Pre 90% Far Site CF update

Mucking drift update

ALTERNATE SECTION

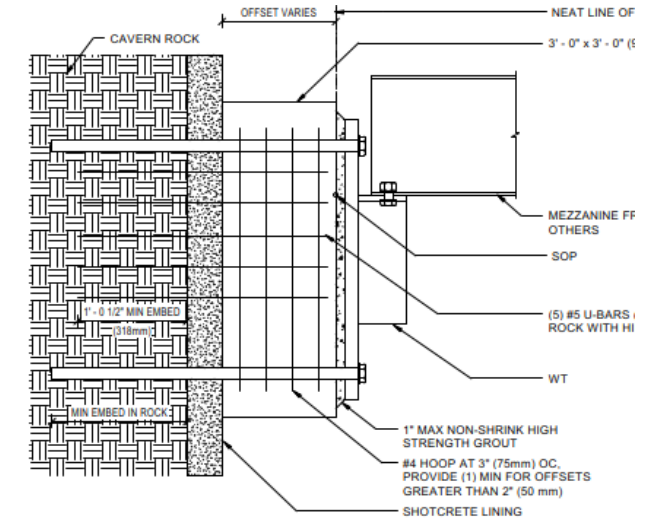
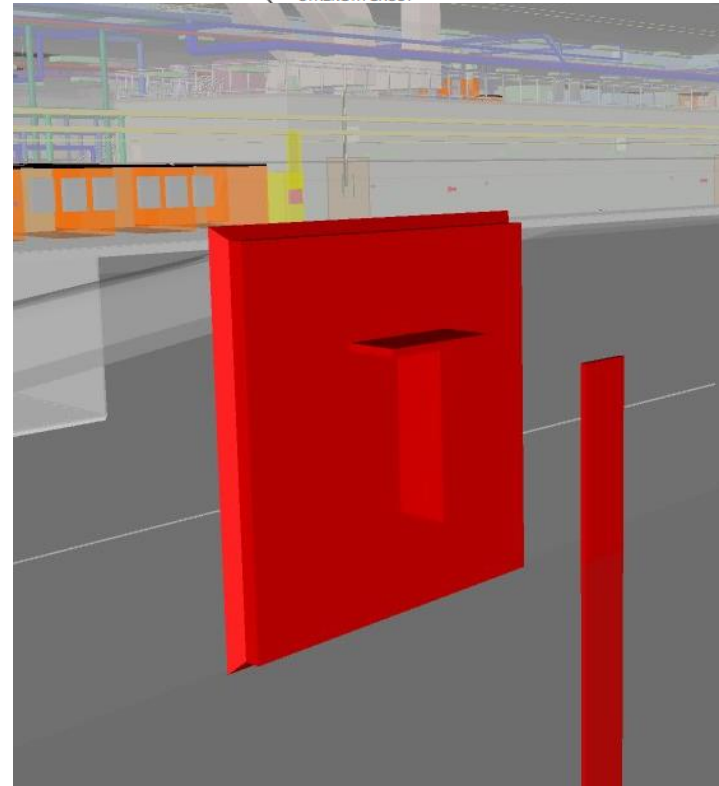
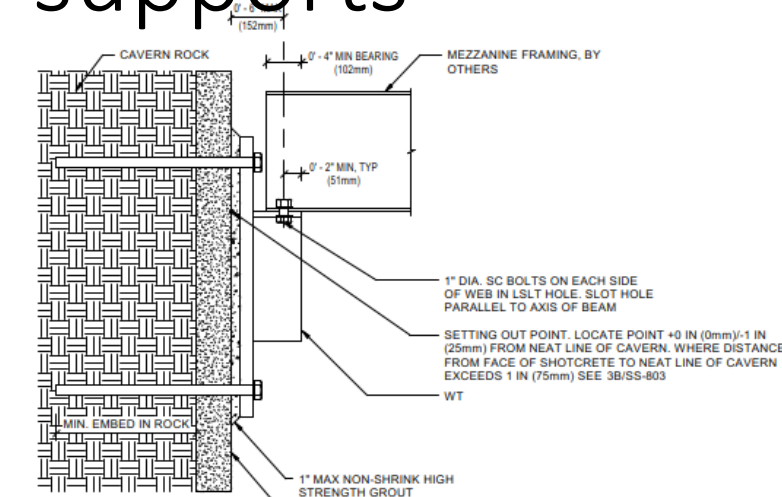
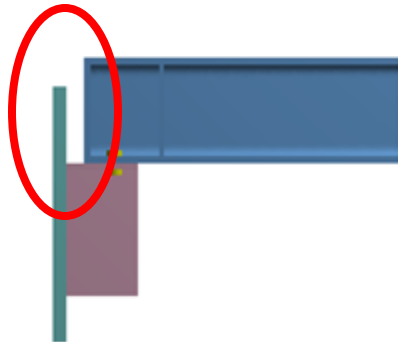
The mounting details of the mezzanine below needs to be clarified.

Mezzanine simulation

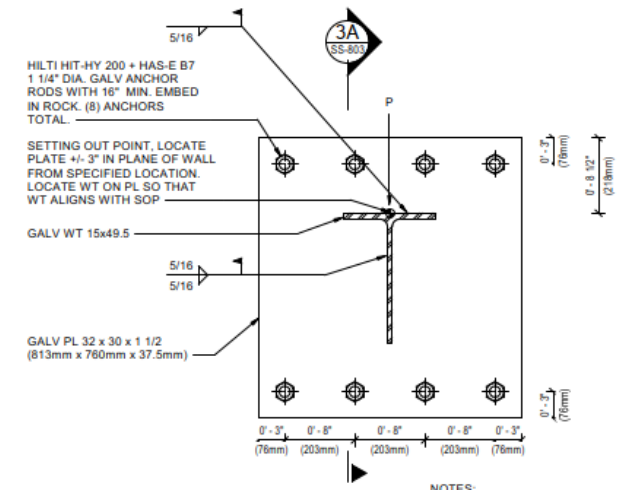
- ARUP asked if a vibration analysis has been performed from any vibrating equipment, personnel or material movement, etc.
- Need to confirm

4910 egress

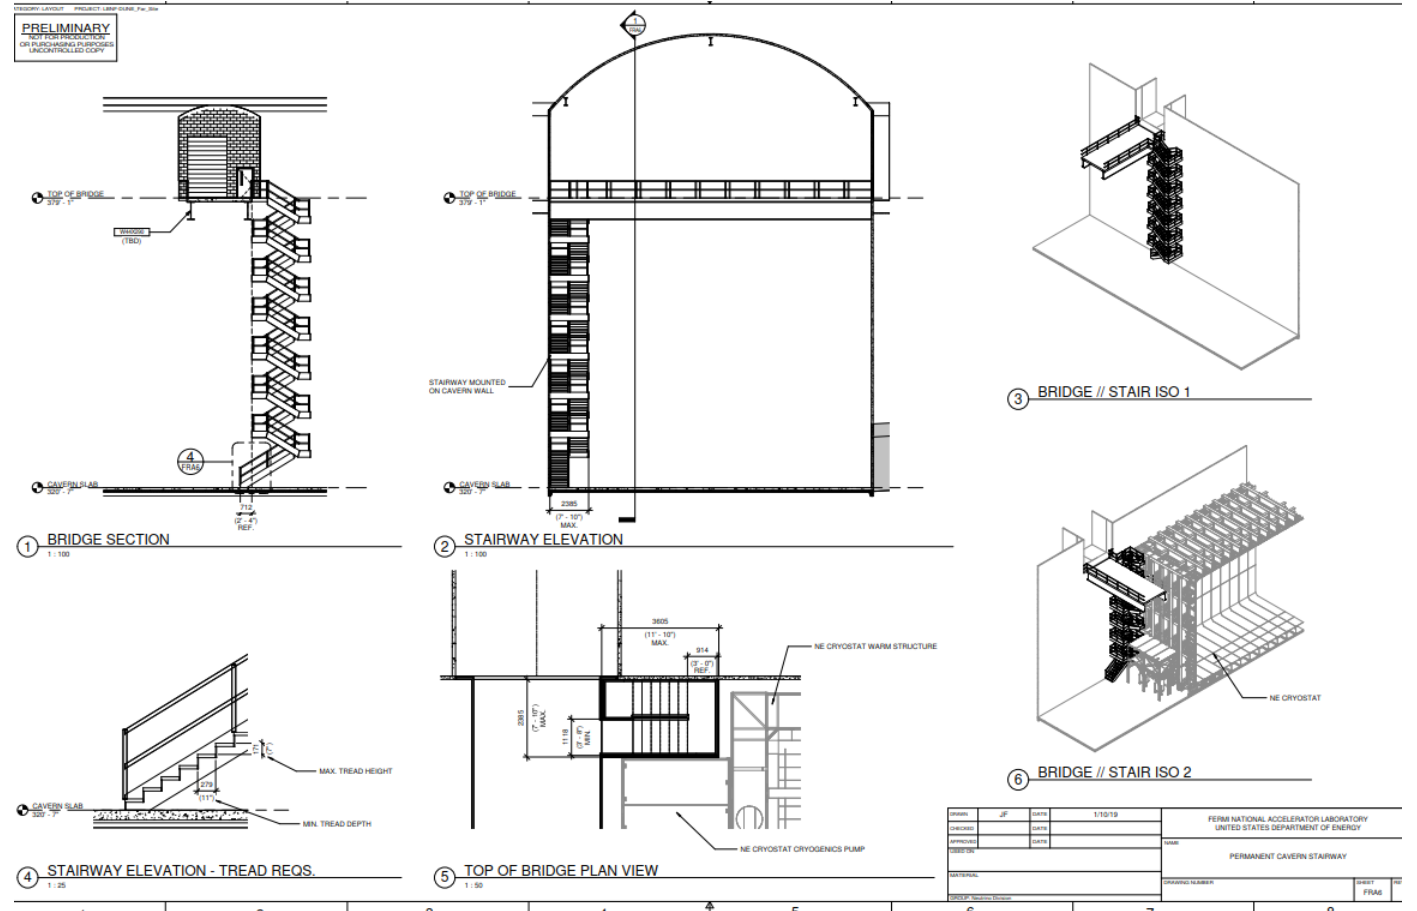
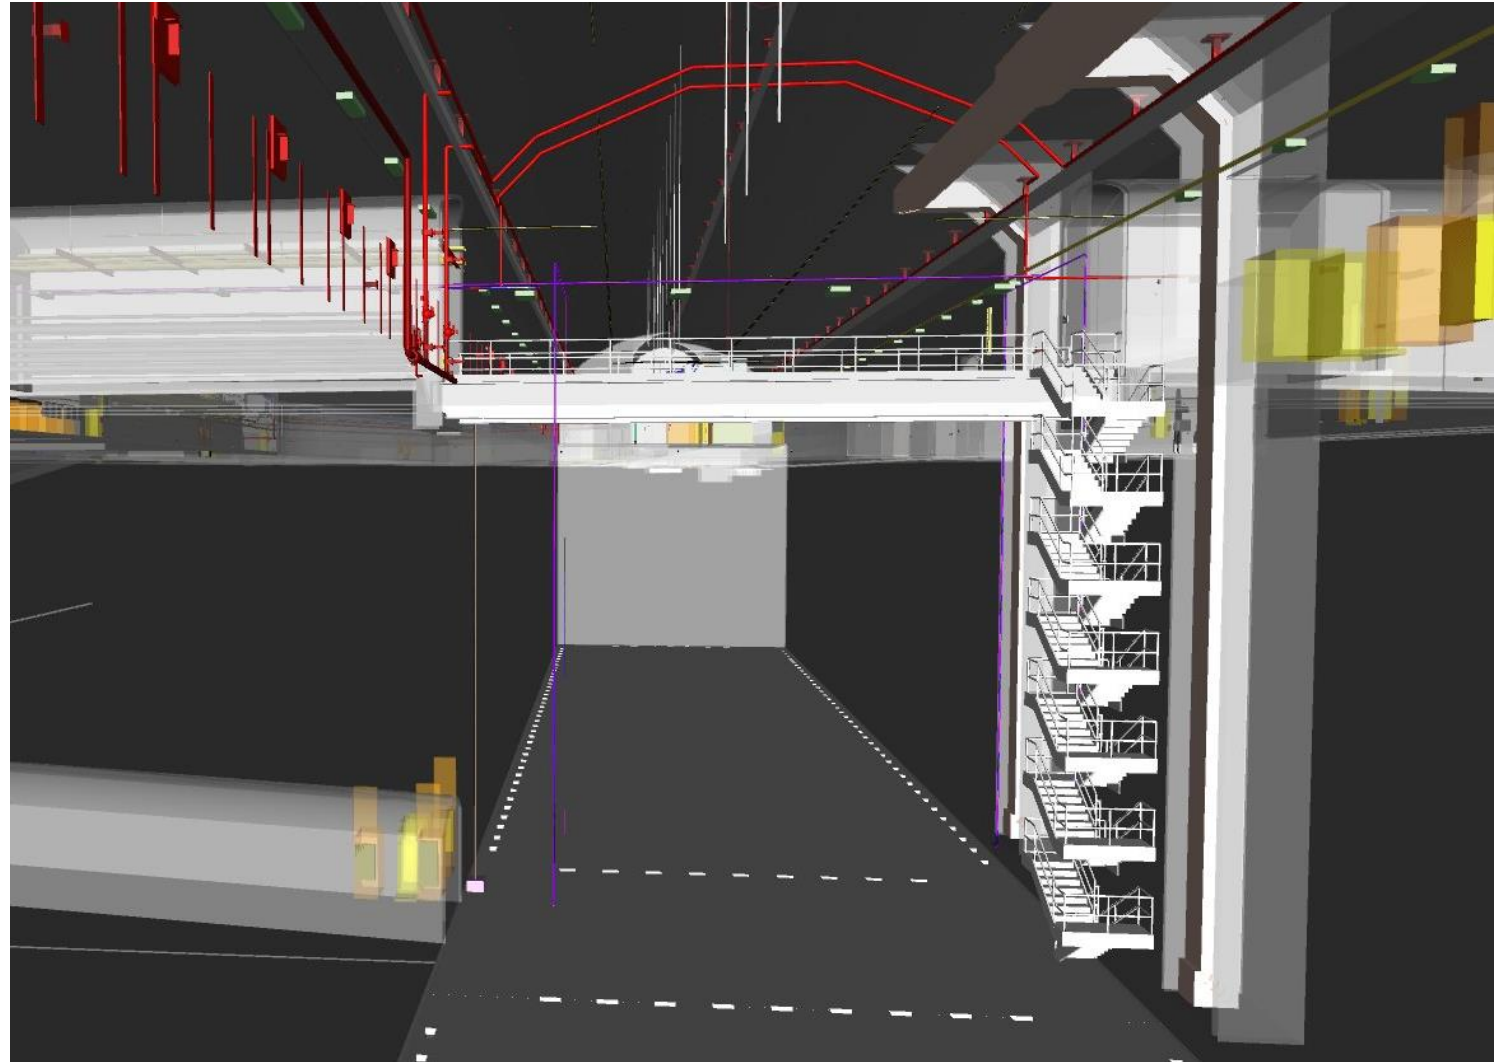
Provided ARUP stair concept and location constraints.

The stairs have been implemented in the latest from ARUP. They are working through the code requirements and interface with bridge and drifts.

The same (mirrored on the CUC) location is foreseen for the south detector cavern.

Bridge abutments

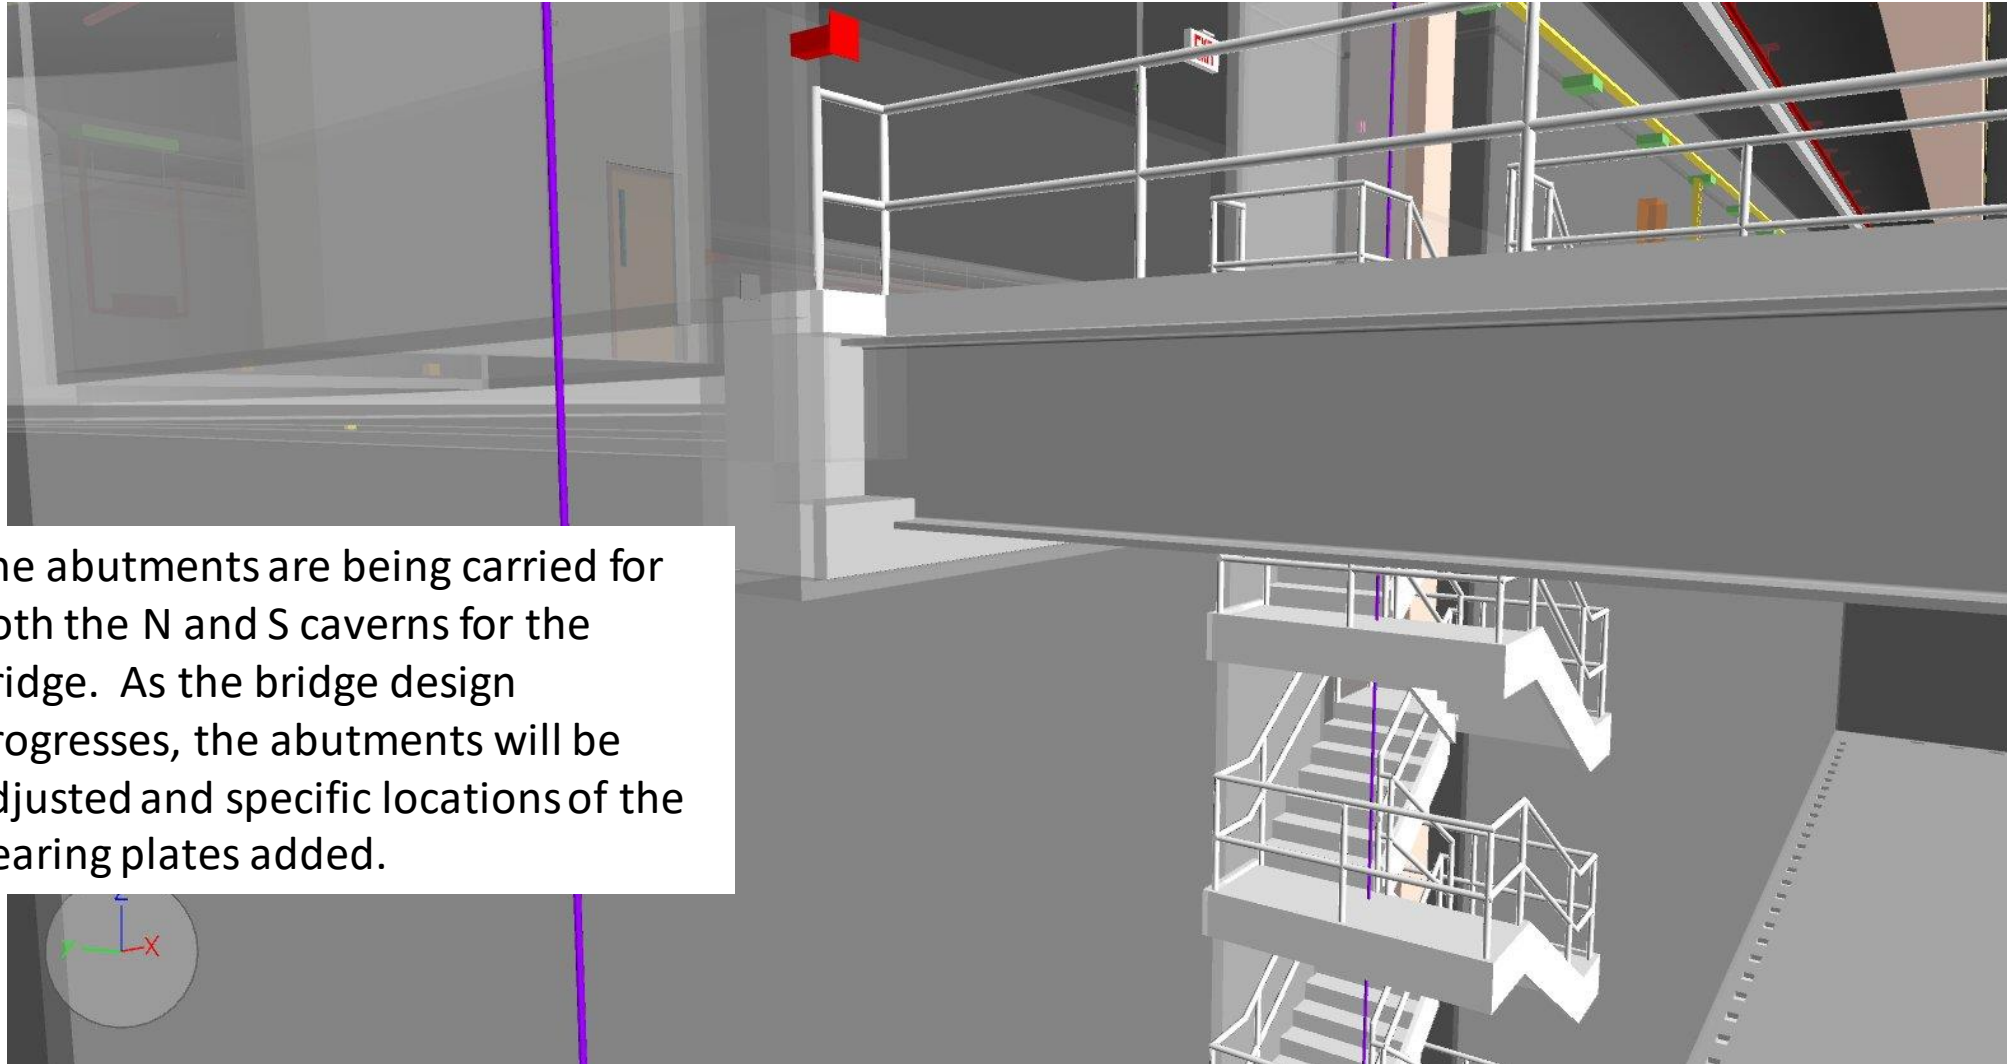
The abutments are being carried for both the N and S caverns for the bridge. As the bridge design progresses, the abutments will be adjusted and specific locations of the bearing plates added.

Experiment rooms in CUC update

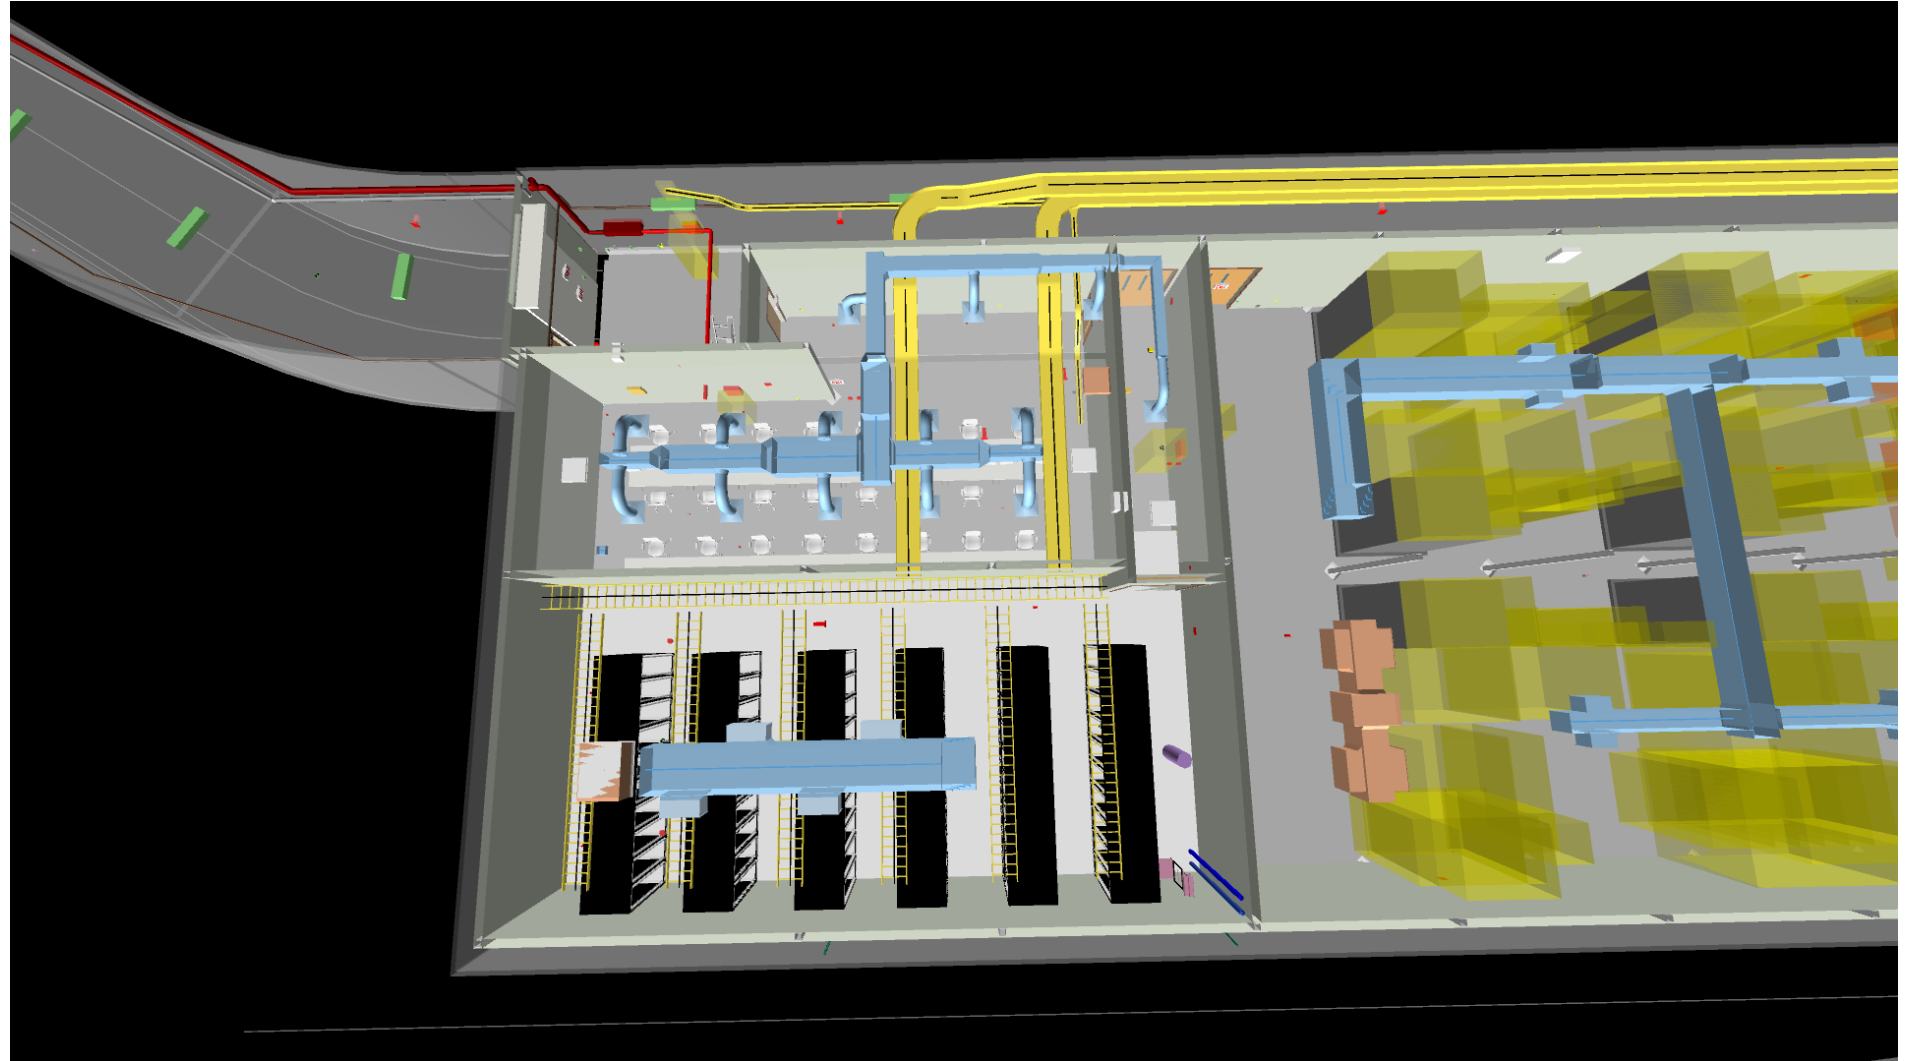
The orientation of the DAQ room and experiment space has been returned to the 30% state. ARUP added a conceptual layout of the racks in the DAQ room. They have asked if we have an integration file that we can share with our models?

Ramp layouts and implications Option 1

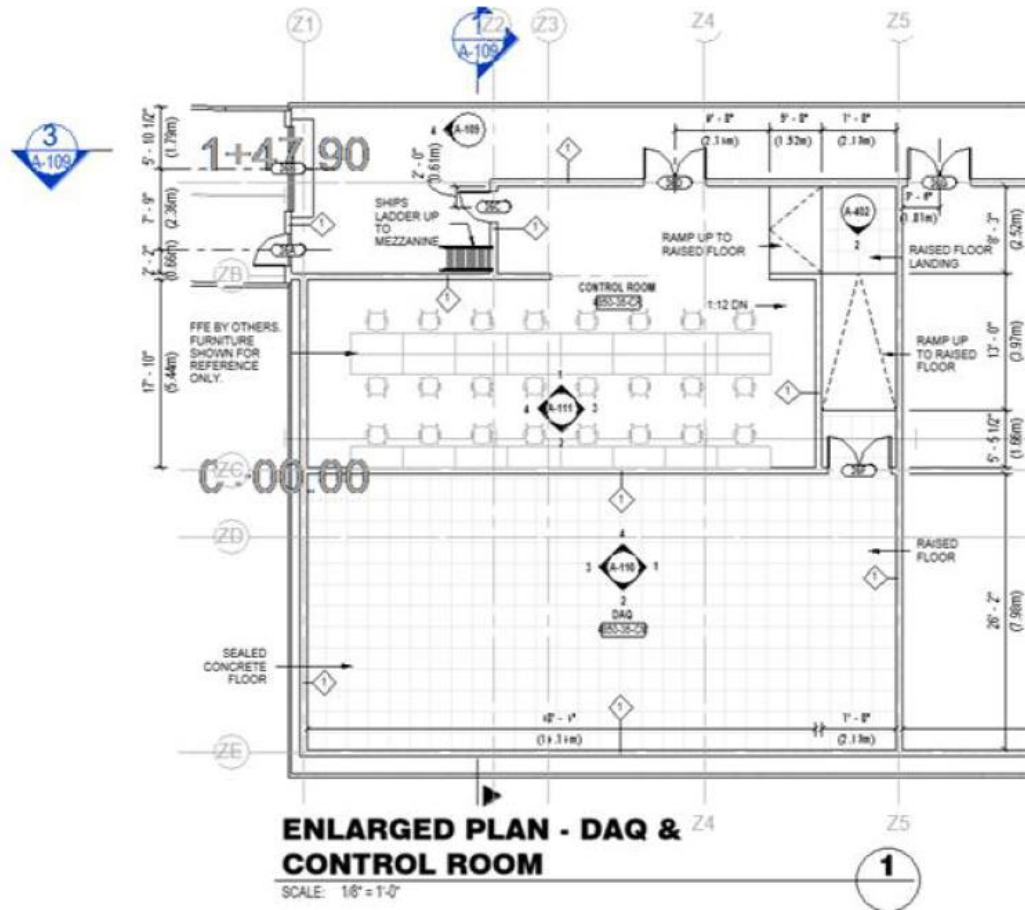
1: This option utilizes the newly removed Kitchenette area to account for the extra length of ramp needed for the 18" raised floor. The benefit of this layout is there is no impact on the DAQ room. The downside is it requires a mid-landing, a 90 turn which may impede maneuverability of equipment up the ramp, as well as through and around the access door at the bottom of the ramp.

Ramp layouts and implications Option 2

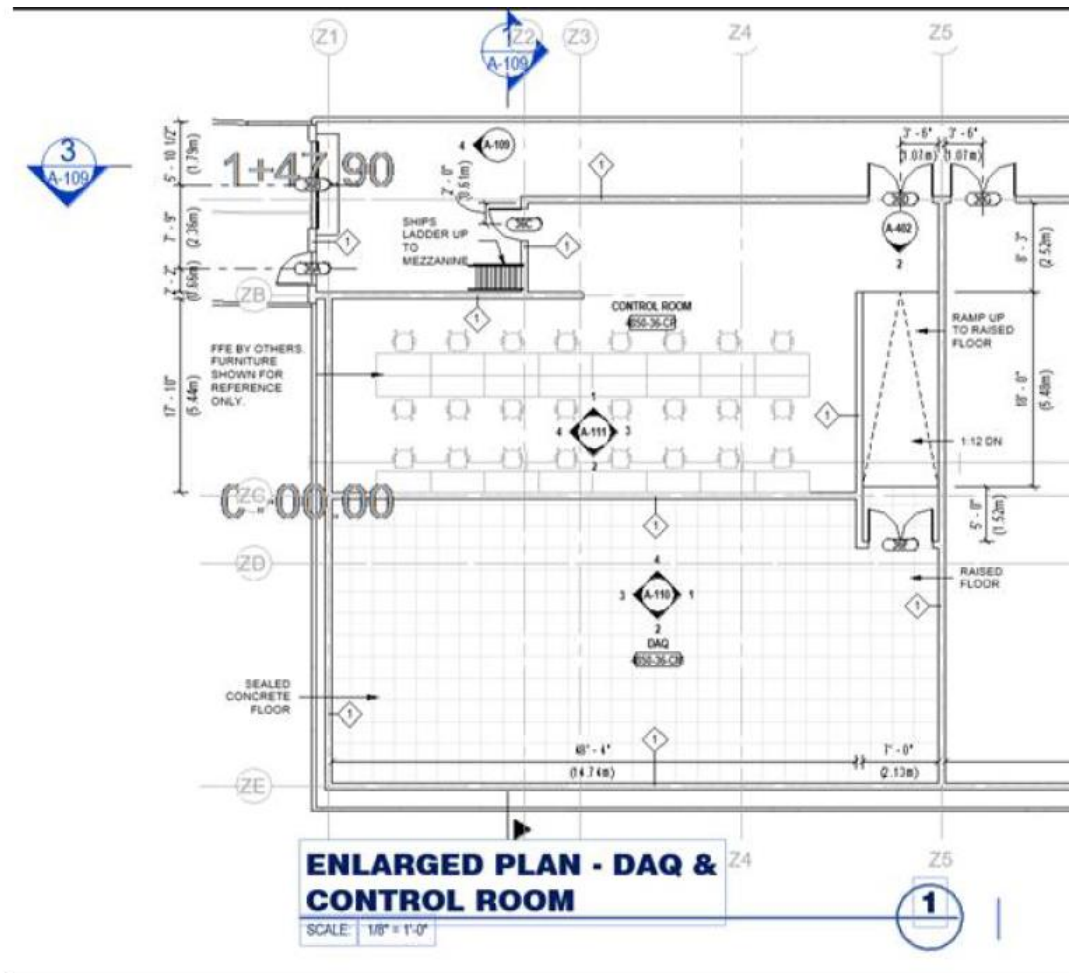
2: This option utilizes space from the DAQ room to fit the entire length of the ramp in the same location as the 30% submission. The benefit of this is it keeps a straight run to the access doors at the bottom of the ramp. The downside is it encroaches on the DAQ room.
